**SAN ANTONIO WATER SYSTEM  
DISTRICT SPECIAL PROJECT (DSP) WELL METER REPLACEMENT PROJECT  
PHASE 3 & 4**

**SAWS JOB NUMBER 13-6103  
SOLICITATION NO. CO-00030**

**ADDENDUM NO. 1  
October 28, 2015**

**PROPOSED PLAN VIEW  
WELL NO. 1 LAYOUT**

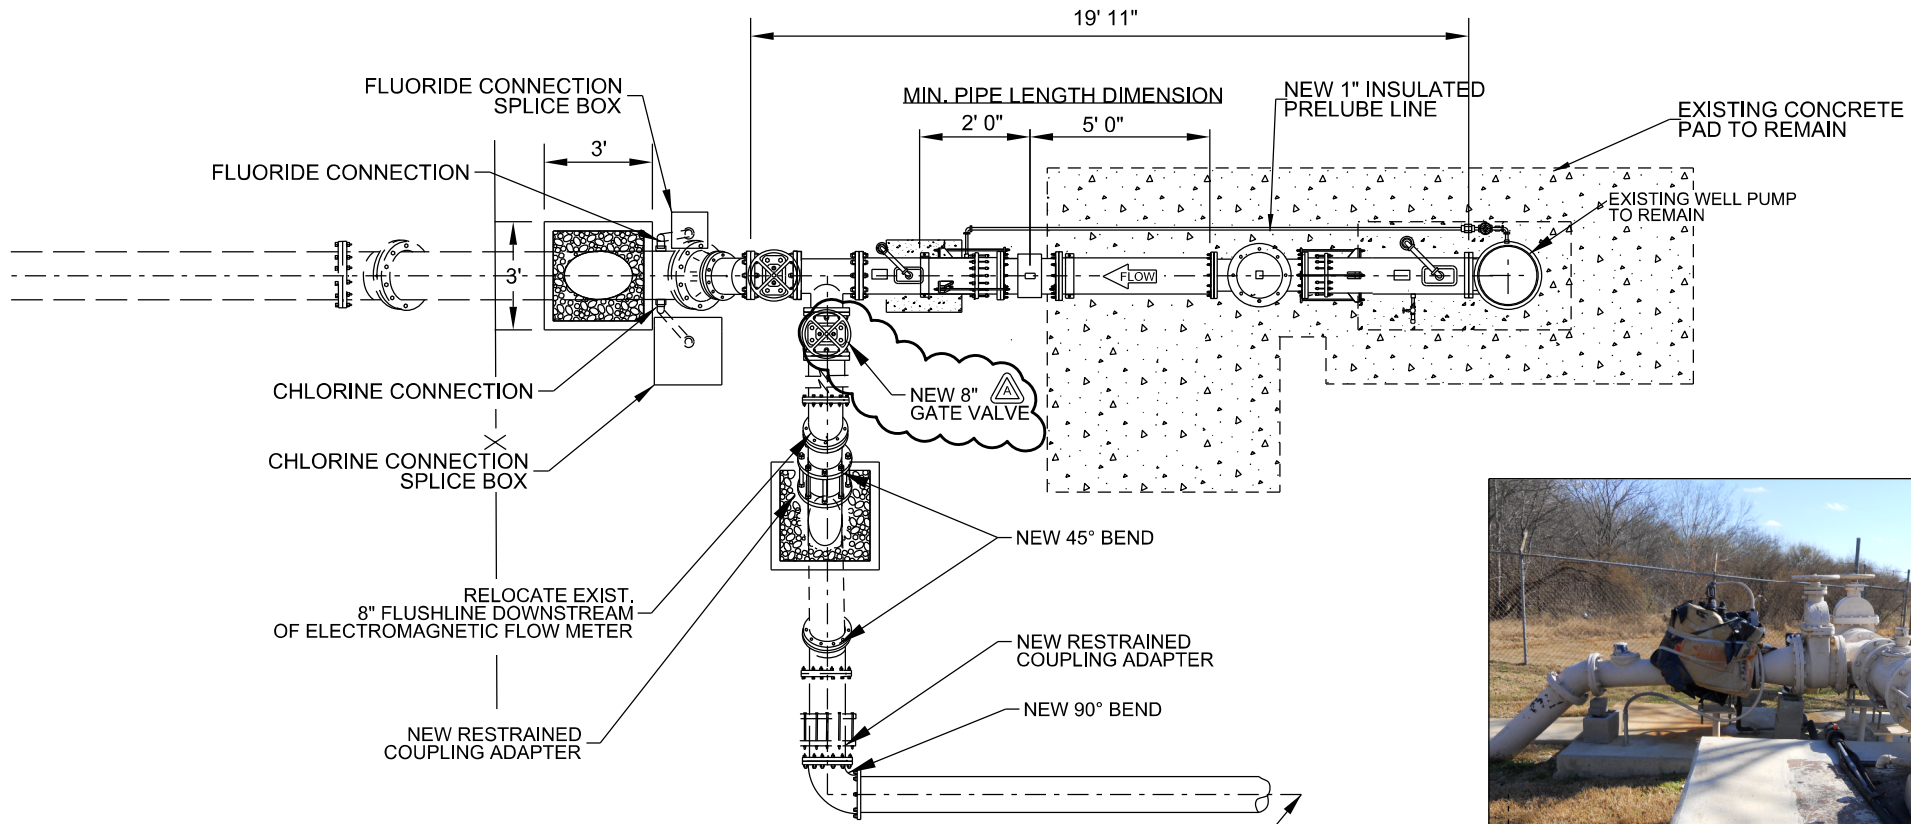
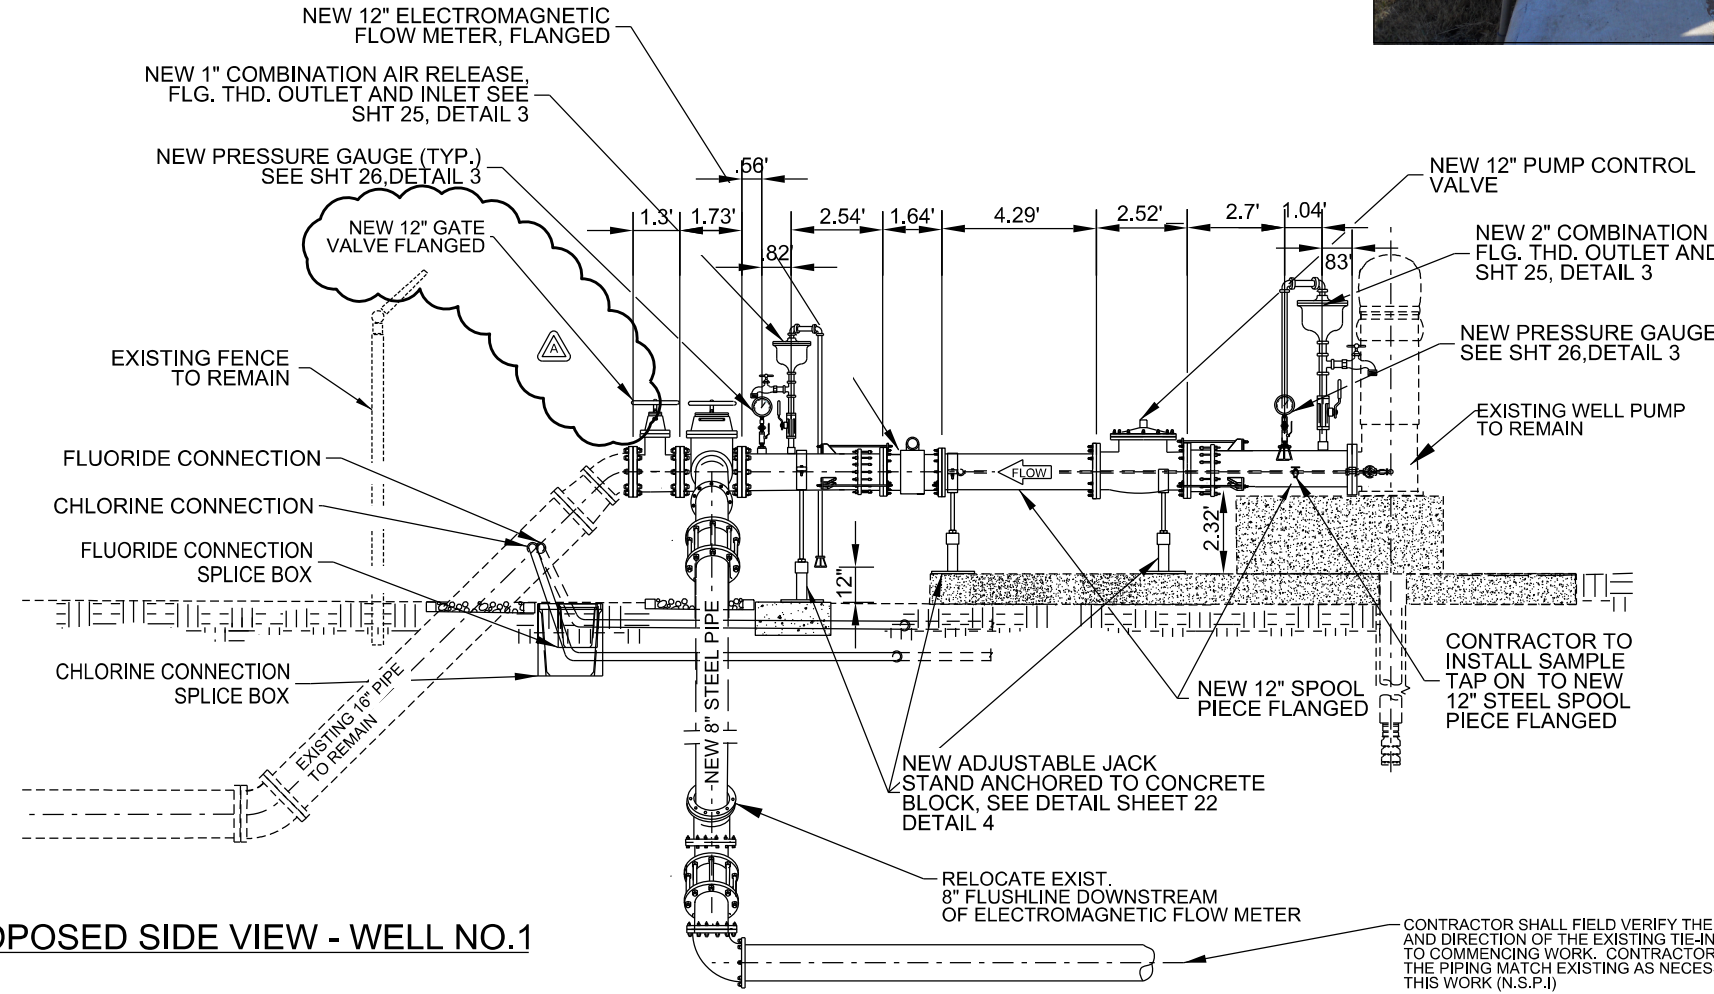
**Sheet 17 of 54**

**Delete Note to Drawing**

*Removed the two (2) 12" Gate Valve callouts on plans.*

**Added Note to Drawing:**

*Added the callouts for one (1) 12" Gate Valve and one (1) 8" Gate Valve at the flushline.*

2. On Plant Sheet 17, the side view calls out 2 each 12" Gate Valves. However, both the plan and side views call out the flush line as being 8" in size. Shouldn't there be 1 each 12" Gate Valve and 1 Each 8" Gate Valve? Please Clarify.

**Response:** *Concur. See Revised Sheet 17 this Addendum #1.*
3. On Plant Sheet 18, on the 12" flush line, it shows a Turbidity Valve and a Butterfly Valve. However, on the Plan Sheet 19, it shows a Turbidity Valve, a Duo-Check Valve, and no Butterfly Valve. Please Clarify?

**PROPOSED PLAN VIEW - WELL NO. 2 LAYOUT**

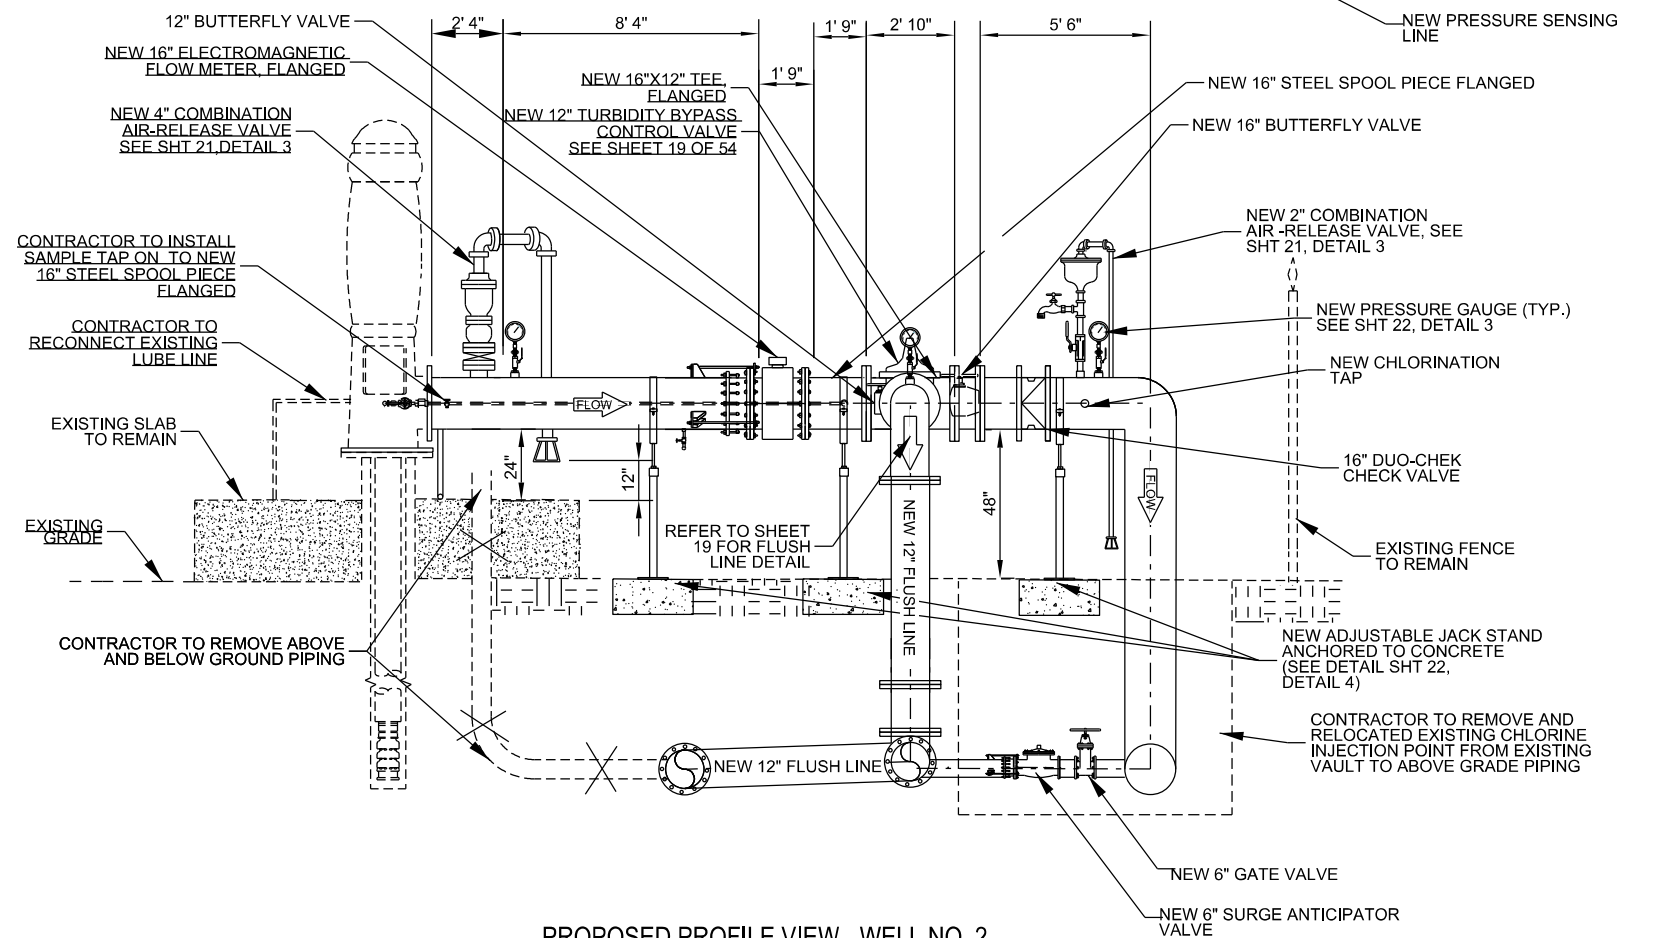
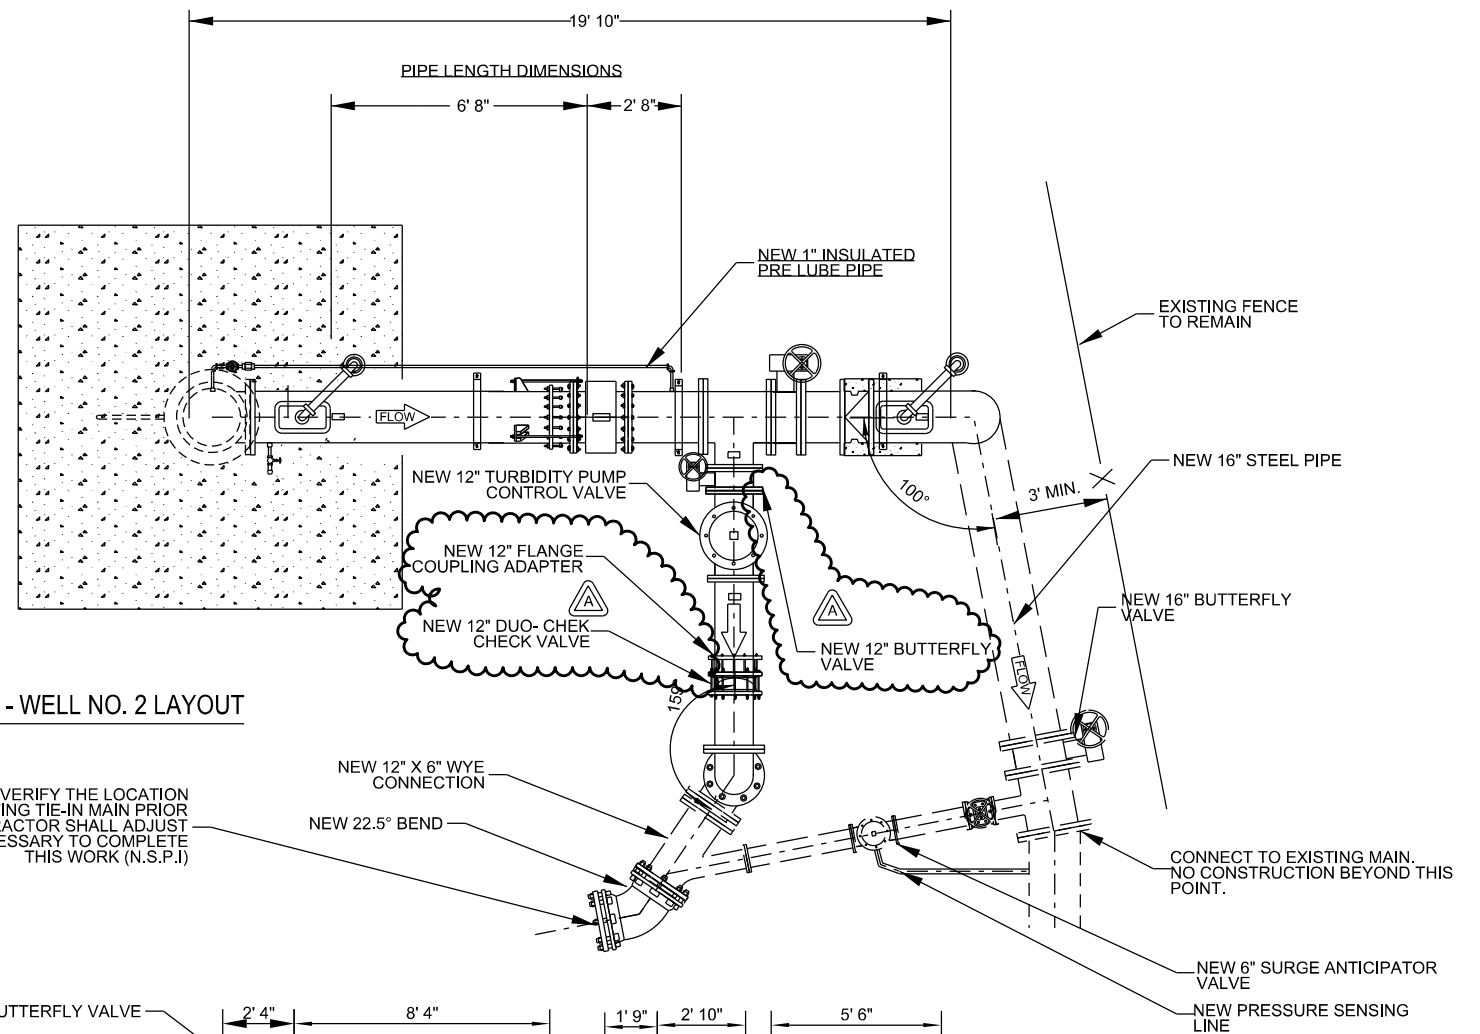
## Sheet 18 of 54

### **Added Note to Drawing:**

*Added the New 12" Duo Chek Check Valve and New 12" Flanged Coupling Adapter callouts and symbols to the plan view.*

**Response:** *Concur. See Revised Sheet 18 this Addendum #1.*
4. Please see the attached specification 15072 section 1.5 "Qualifications" taken from the SAWS DSP Clayton Tank project. The "Qualifications" for the Welded Steel Pipe and Fittings which was included in the specifications for the "SAWS DSP Clayton Tank" project was not included in specification 15072 for the "SAWS DSP Well Meter Replacement" project. Please confirm if this "Qualification" will also be required for the SAWS DSP Well Meter Replacement project.

DSP WELL METER REPLACEMENT PROJECT  
 FACILITY NO. 065  
 105 BITTERS RD.  
 FLUSH DETAIL WELL NO. 2

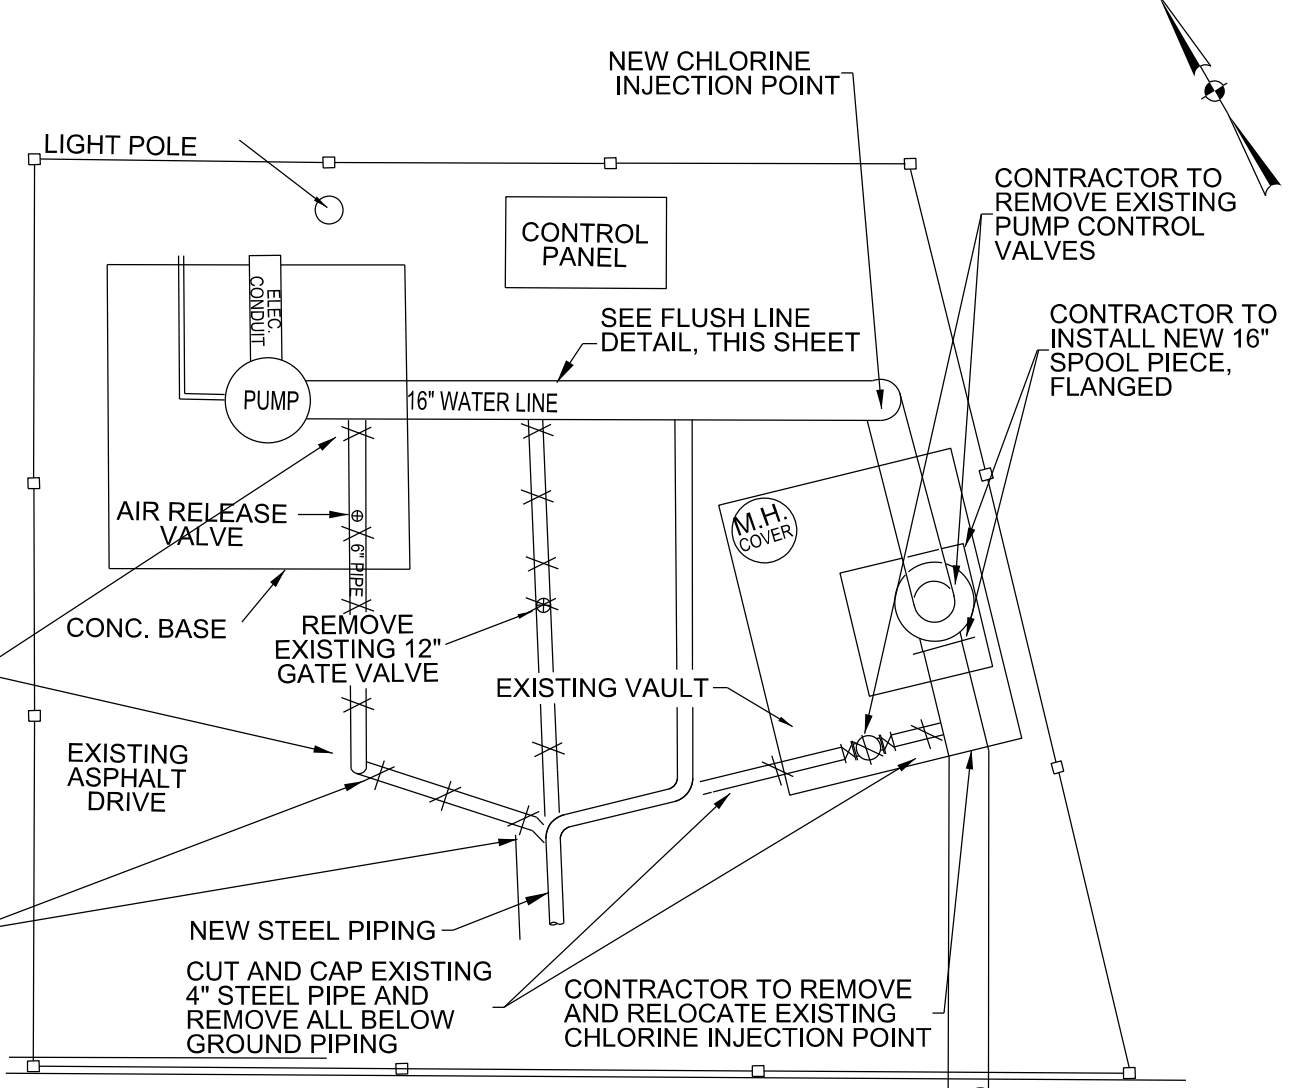
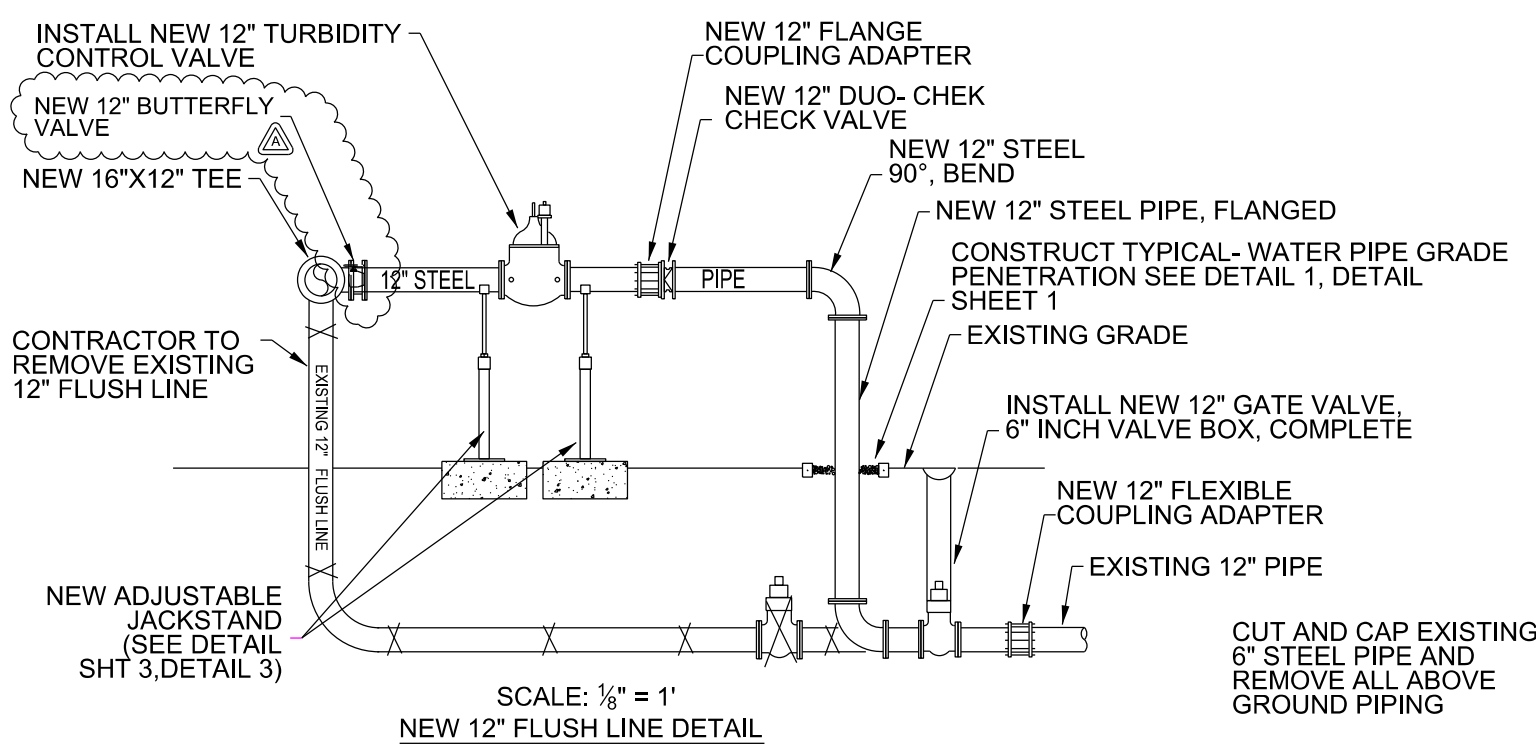
## Sheet 19 of 54

### **Added Note to Drawing:**

*Added the New 12" Butterfly Valve callouts and symbols to the plan view.*
